PRODUCT REFERENCE MEMO

AVAILABILITY OF KIT TO RETROFIT OBSOLETE BRAKE MODEL 30-181 TO BECOME 30-181A

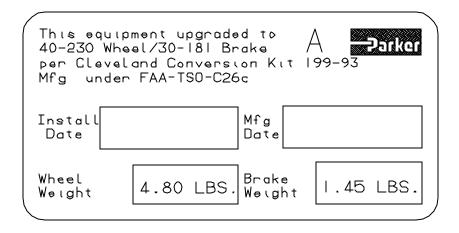
PURPOSE: Cleveland Brake Model 30-181 and Lining P/N 066-10200 are now obsolete, and spares

support will no longer be offered. It is suggested that all 30-181 brakes be retrofitted to

become 30-181A per Kit 199-200 and this PRM.

- Unless wheel maintenance is required, this procedure can be done without jacking aircraft. It is, however, suggested that brake discs be inspected per Manual and replaced, if needed, at this time.
- 2. Assure that all hydraulic pressure is relieved from brakes and remove backplates and pressure plates, as required, to replace linings.
- 3. Discard existing aluminum backplate shims P/N 068-12300 (1 ea.) and tie bolts P/N 103-12000 (2 ea.). Retain and reuse tie bolt washers P/N 095-10200 (2 ea.).
- 4. Remove old lining from pressure and backplate by drilling out all rivets using a 5/32 inch drill. Install new linings P/N 066-10600 with new rivets P/N 105-00200.
- 5. Clean exposed surfaces of piston and push fully back into cylinder.

REQUIRED: Kit 199-200
